PROJECT: REMINGTON COMMERCIAL (UPDATE TO DURANGO 495 COMM)

SUBMITTAL: 1ST

CITY OF LAS VEGAS		DATE:
INTER-OFFICE MEMORANDUM		August 6, 2015
TO: Land Development Services Department of Building & Safety		FROM: Albert Sung, P.E. Flood Control Project Engineer Department of Public Works
SUBJECT:	Drainage Study for:	COPIES TO:
	Remington Commercial VIII (Update to Durango & 95 Commercial)	Baughman & Turner, Inc.
Cross Streets:	NEC of Oso Blanca Road & Severance Lane	Remington Commercial VIII, LLC
File Number:	F:\Depot\DSMemos\DS4743A.doc	Bart Anderson, P.E., DevCo
Parcel Number:	125-17-301-012	NDOT
Zoning Action:	TMP-59501; SDR-58128; SUP-58125; SUP-58126 & SUP-58127	
FEMA Flood Zone	YES NO X	
Proposed Storm Drain	YES NO X

GP02

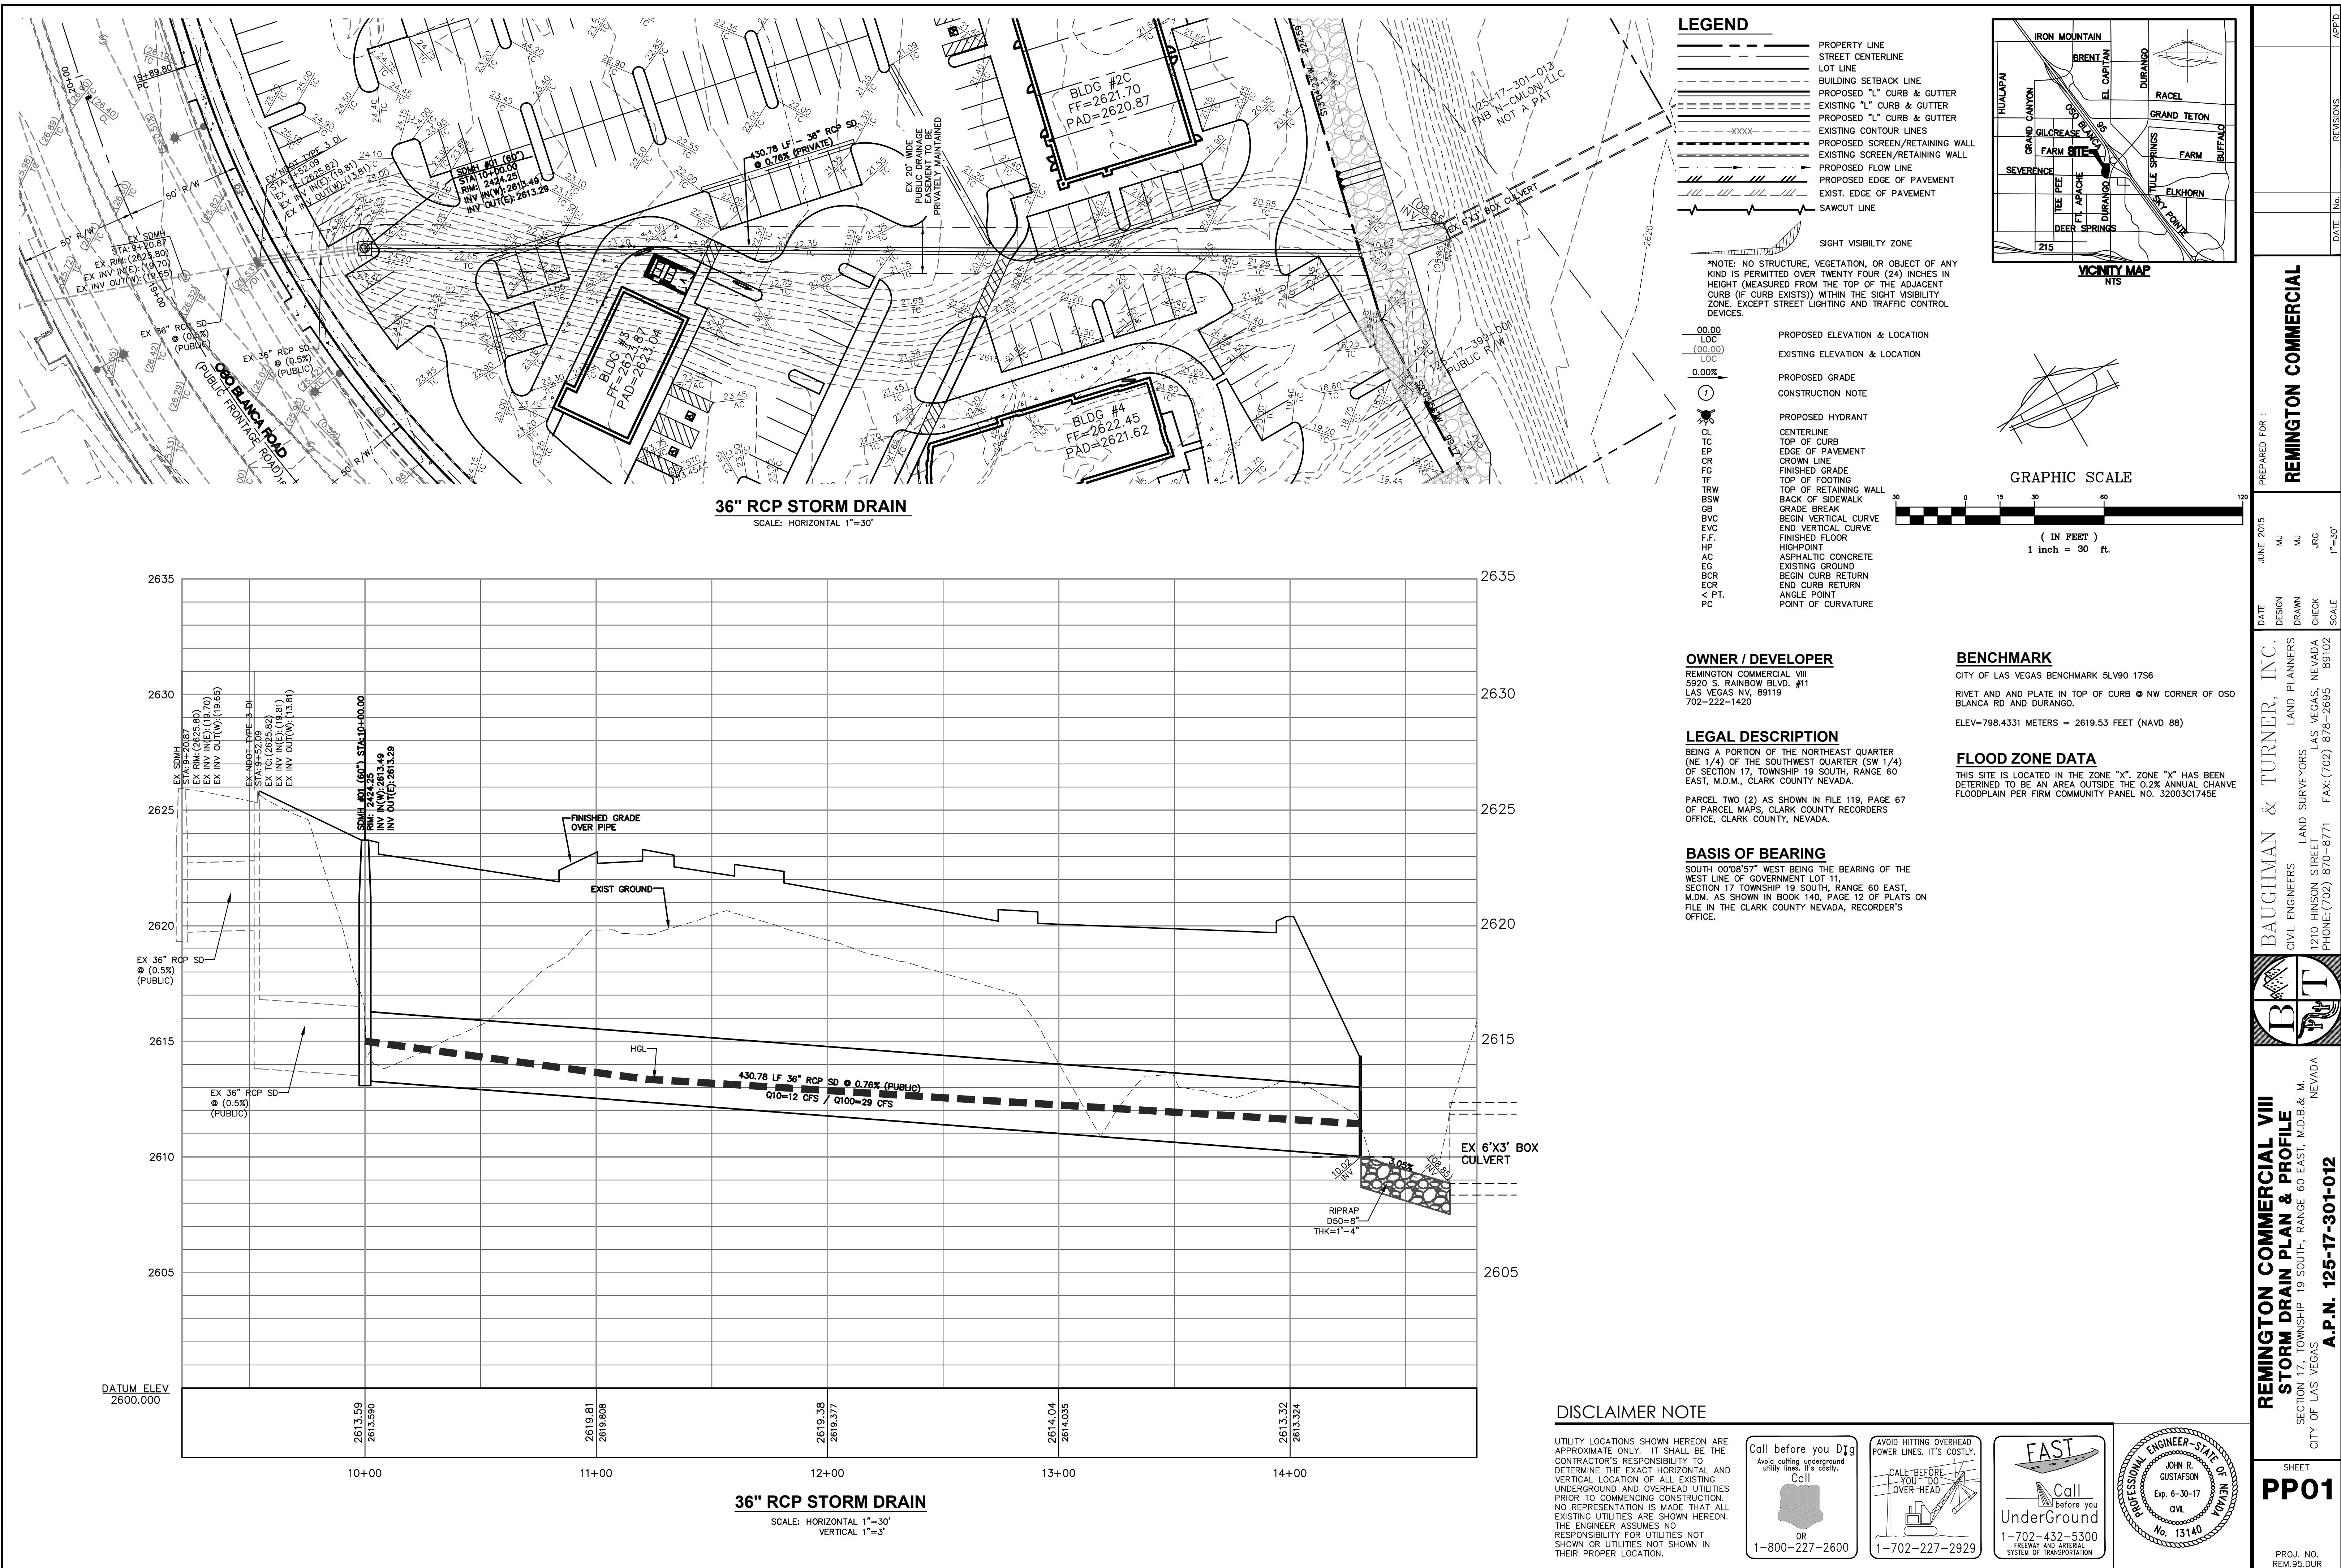
5. **Sheet GP-02:** Per the drainage study, the 100-year flow depth at the east side of *Oso Blanca Road* at *Severance Lane* is 0.98ft. The proposed hump (25.00TC/HP and 24.95TC/HP) at the entrance driveway does not provide adequate freeboard which is a minimum of six (6") inches. Review and revise accordingly.
6. **Sheet GP-02:** Label an existing 20'-wide public drainage easement (privately maintained) with recorded document or parcel map number in the next submittal.
7. Revise the construction note for riprap installation per NDOT Standard Drawing R-3.1.5.
8. Provide a section in the drainage study to address the design and calculations (per CCRFCD Section 1500 of the *Hydrologic and Hydraulic Design Manual*) of stormwater quality features for low impact parking lot in the next submittal.

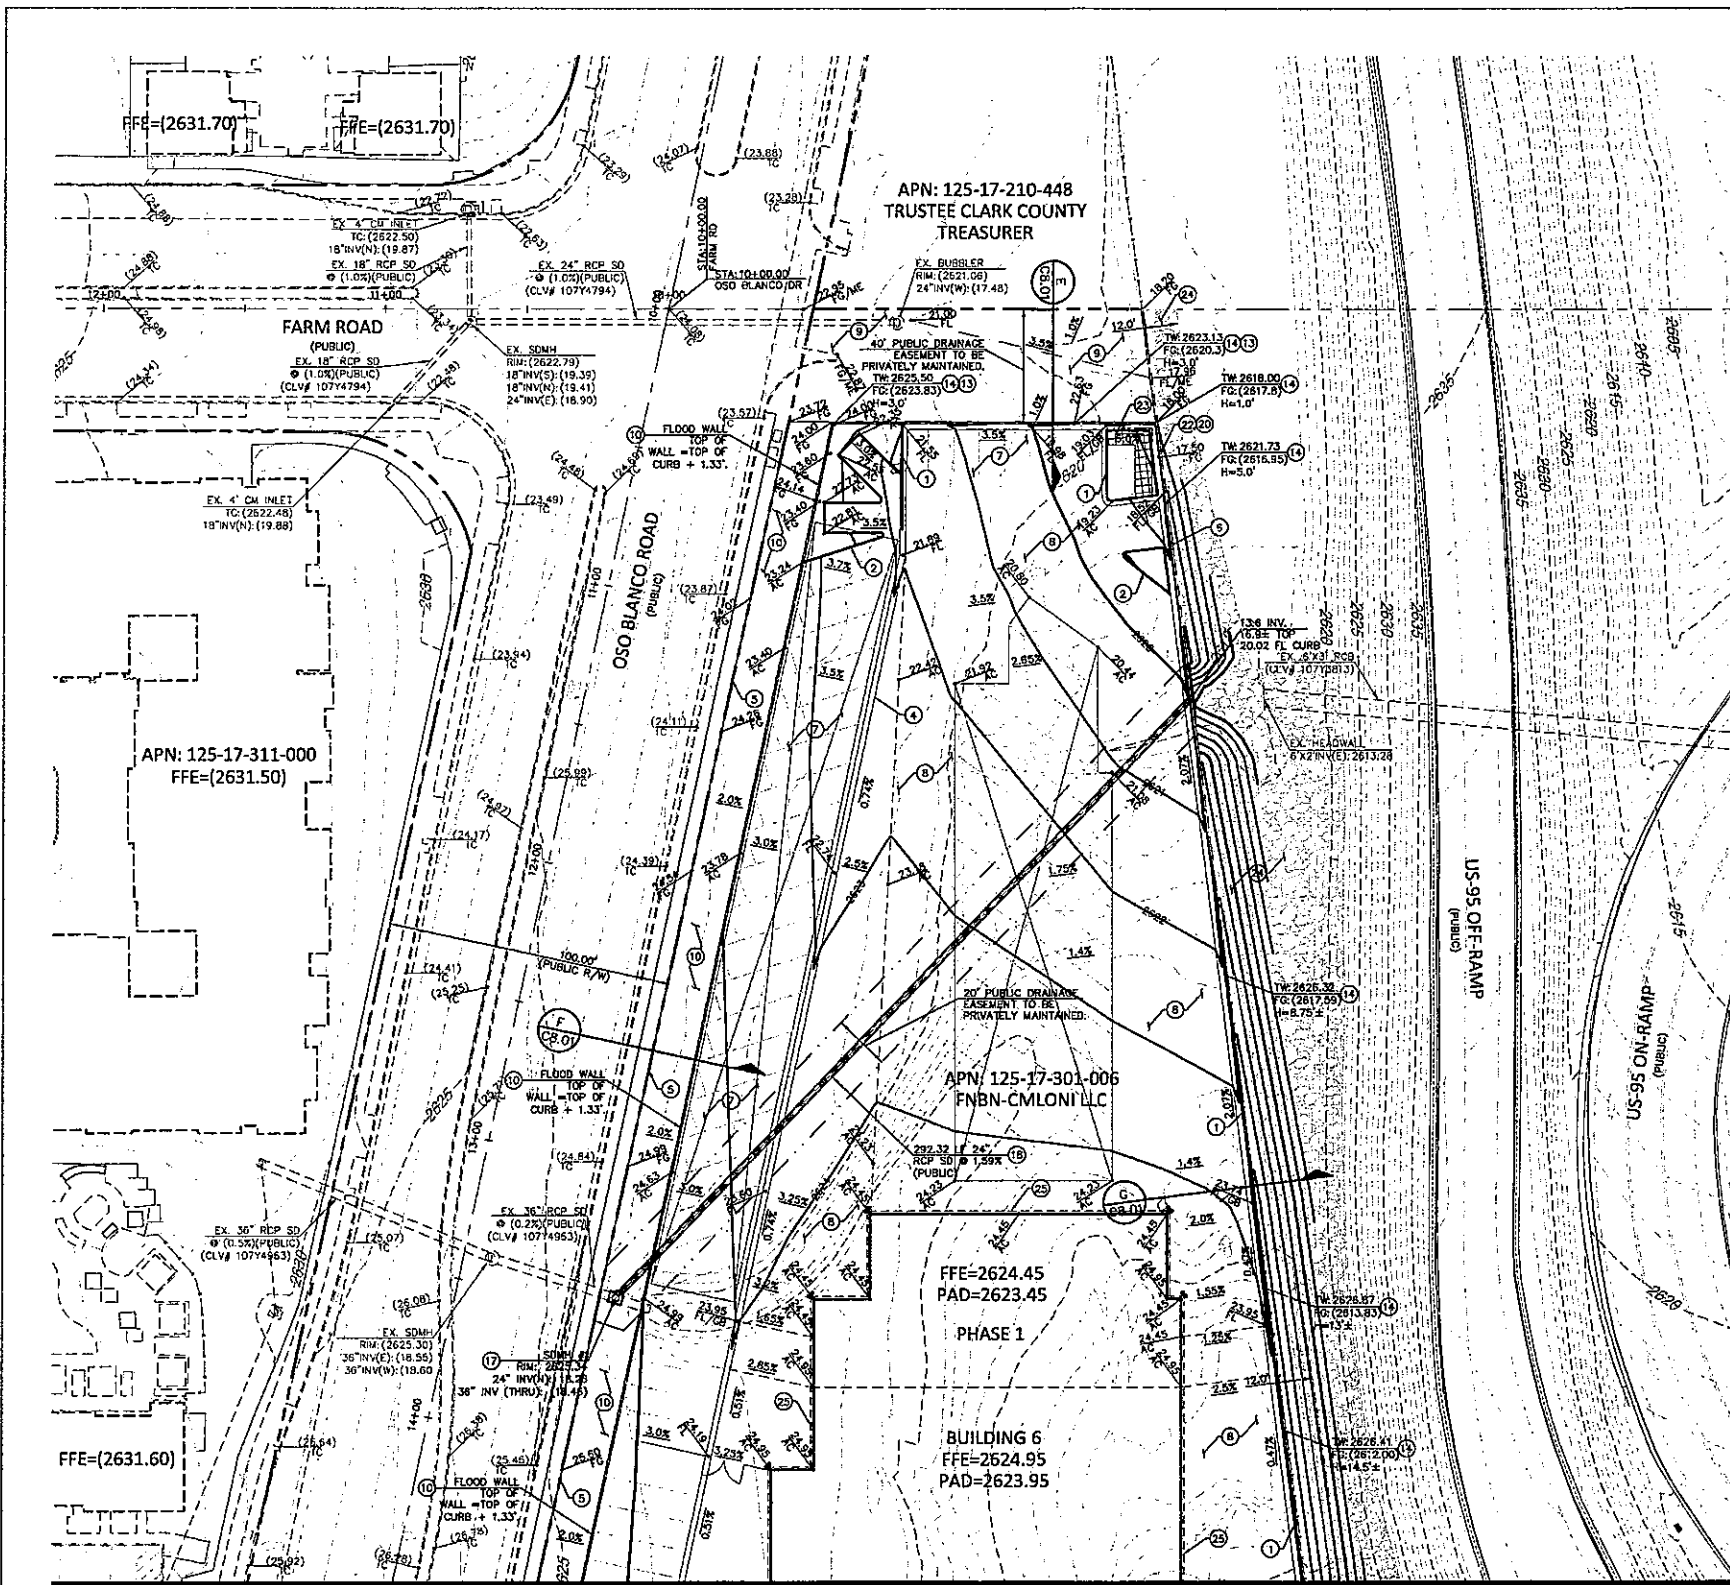
Second request: Sheet C4.03: The hump in the driveway entrance off of Severance Lane intersection does not have six inches (6") minimum freeboard. Review and revised accordingly.

Sheet C4.03: Show the parcel line limit between Parcel 2 and Parcel 3 as identified in the proposed parcel map.

Second Request: Label existing storm drain systems in the perimeter streets with City of Las Vegas recoded drawing number on all pertinent plans-Existing storm drain in Oso Blanca Road has not been labeled (sheet C4.03)

Sheet C4.03 has been revised to show the proposed parcel line as depicted on the attached Parcel Map (see Appendix C). There is no parcel line division at this time.

We apologize for the omission in the previous submittal. Sheet C4.03 has been revised and included in Appendix C.

FIGURE 12

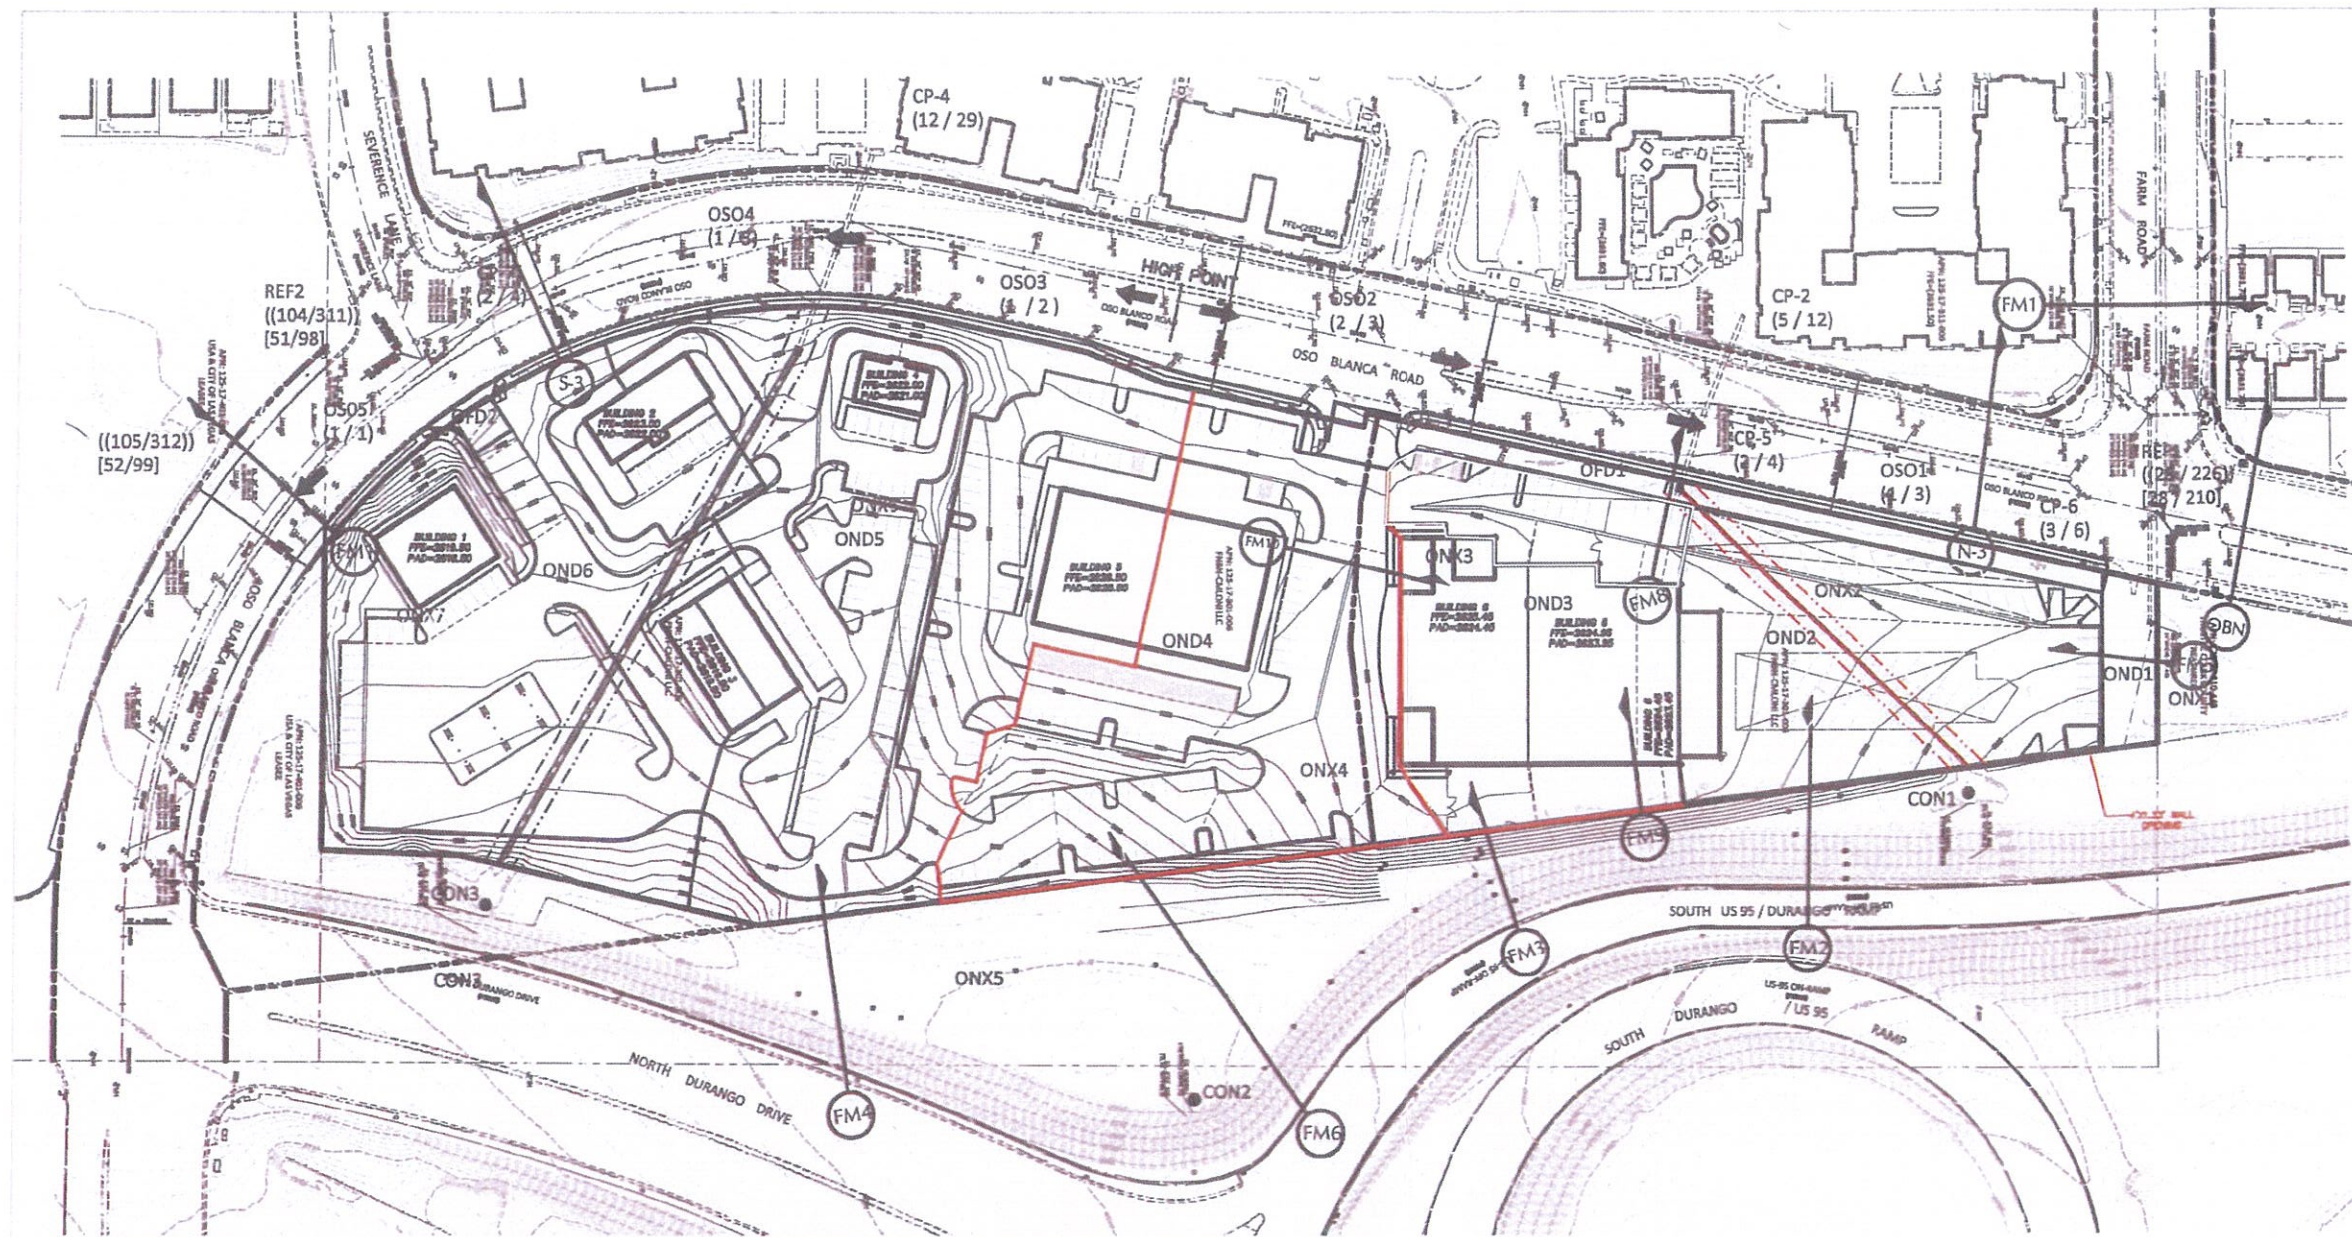
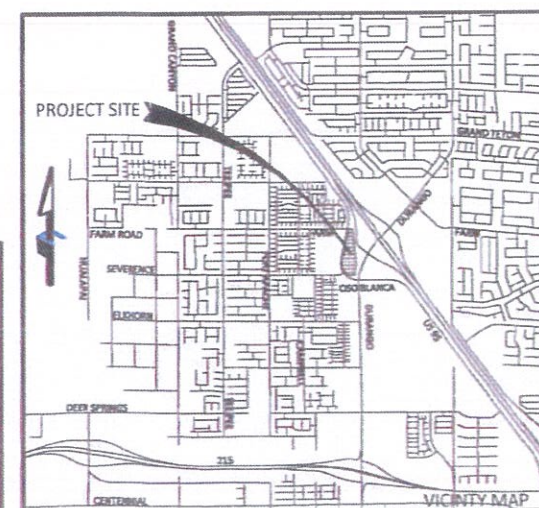
Developed Condition Drainage Basin Map (Figure 12): The revised 100-year overflow into the corridor adjacent to the north of the subject site is 494 cfs per the last addendum. However, the Q100 show in the flow analysis summary table is only 311 cfs (Section FM1), please address and resolve in the next submittal. Revise hydraulic calculation of FM1 and FM2 accordingly.

The sections have been revised and updated on the Basin Map. Per revised plan, section FM1 is located at the south end of Oso Blanca at Severance and represents the 312 cfs in the street. Section FM5 has been added to show the 494 cfs and the depth of flow along the proposed 40' drainage easement. Section FM6 has been added for information purposes and calculations. For the locations of these sections, please refer to Figure 12 in Appendix A.

The hydraulic sections (FM2, FM3, FM4, FM5 and FM6) are cut to show the flow depth and velocity along the east side of the property. The FlowMaster calculations of the sections are provided in Appendix B and the Flow Depth Analysis Summary table has been updated on Figure 12 Appendix A.
